**CITY OF MERIDIAN
FINDINGS OF FACT, CONCLUSIONS OF LAW
AND DECISION & ORDER**

In the Matter of the Request for Annexation & Zoning of 7.35 acres of land with an R-8 zoning district and Preliminary Plat consisting of 22 building lots and 4 common lots for Teakwood Place Subdivision, by Hesscomm, Corp.

Case No(s). H-2020-0006

HEARING DATE: 11/17/2020
TO: Mayor & City Council
FROM: Joe Dodson, Associate Planner
208-884-5533
Bruce Freckleton, Development Services Manager
208-887-2211
SUBJECT: H-2020-0006
Teakwood Place Subdivision

B. Preliminary Plat (date: 3/25/2020/6/24/2020 8/12/2020)

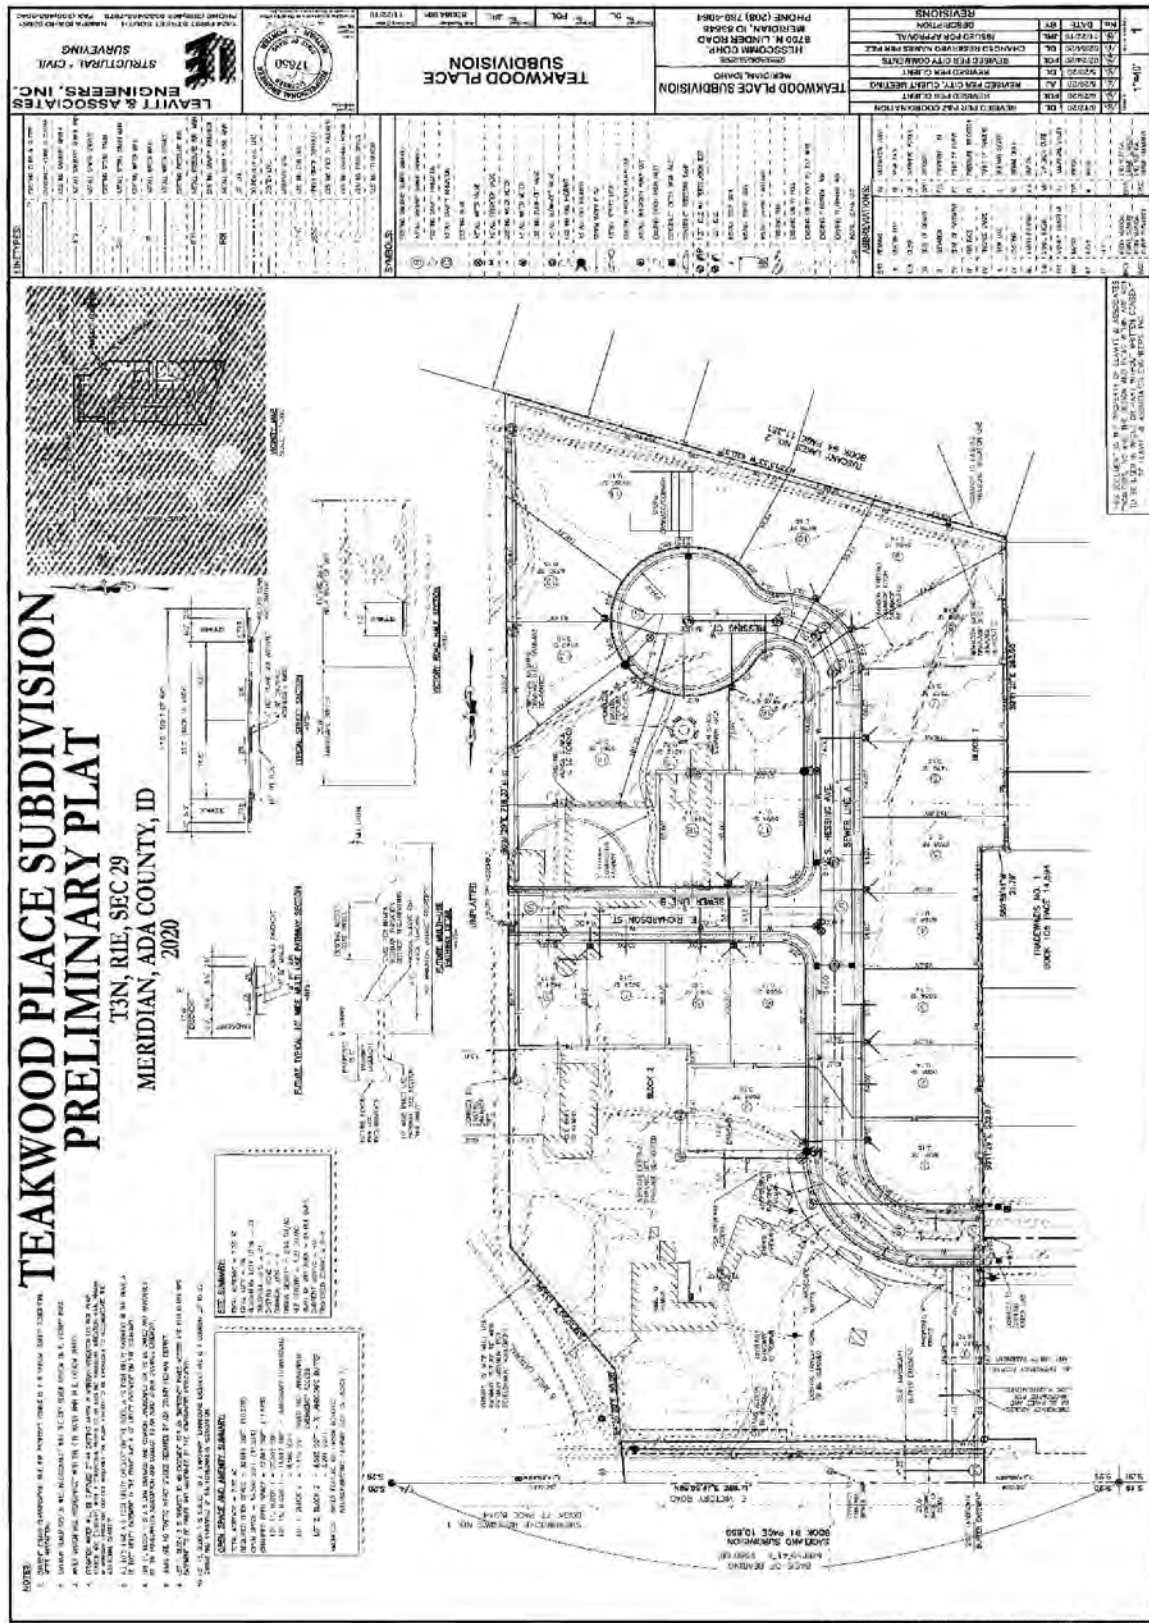
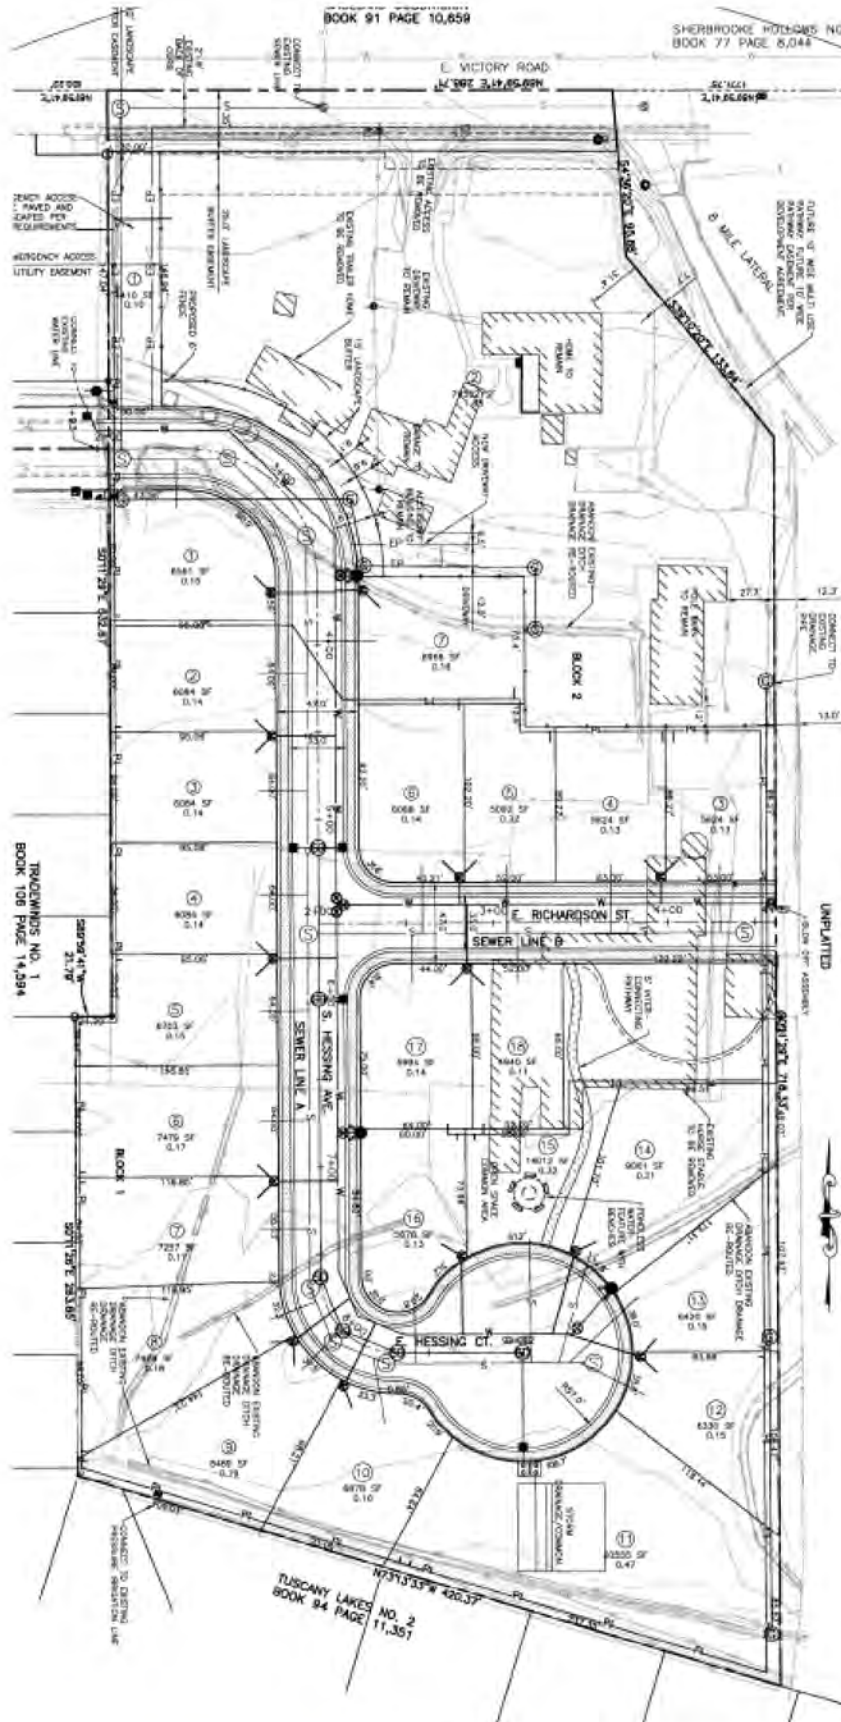
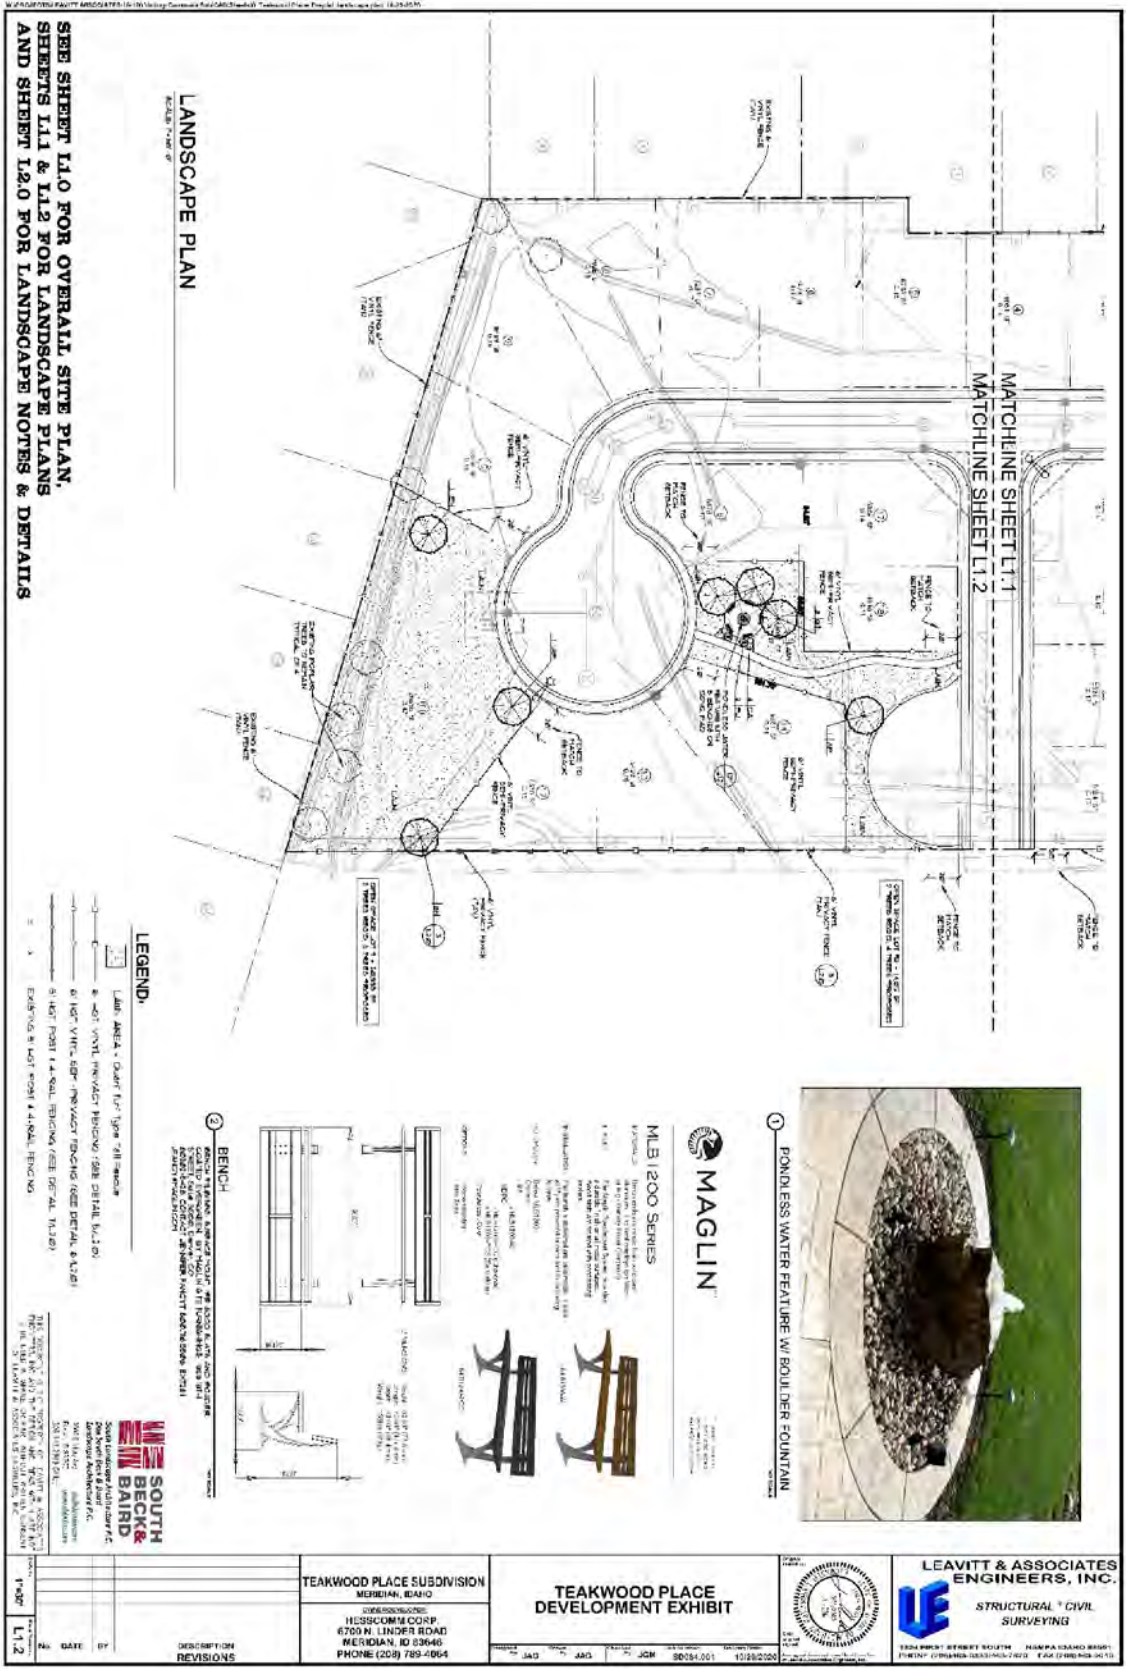
- l. All stormwater detention facilities shall be designed to completely drain within a 12-hour period.
2. The preliminary plat included in Section VII.B, and dated ~~03/25/2020~~06/24/2020 ~~8/12/2020~~, prepared by Leavitt Associates Engineers, Inc., shall be revised as follows prior to submittal of the final plat application.

- ~~a. Revise the plat to show the temporary cul-de-sac on the south side of the proposed E. Richardson St., on Lot 21 or 22, Block 1 and add a note stating that said lot is non-buildable until such time as E. Richardson St. is extended.~~

- b. Add a note prohibiting direct lot access via E. Victory Road. Lot 2, Block 2 shall take access from E. Fathom St in accord with UDC 11-3A-3.
 - ~~c. The emergency access on Lot 5, Block 2 shall be constructed prior to any issuance of Certificate of Occupancy.~~

- e. Add an additional common lot along Victory Road to contain the required 25-foot wide landscape street buffer or apply for Alternative Compliance with final plat submittal to request the buffer to be within an easement.
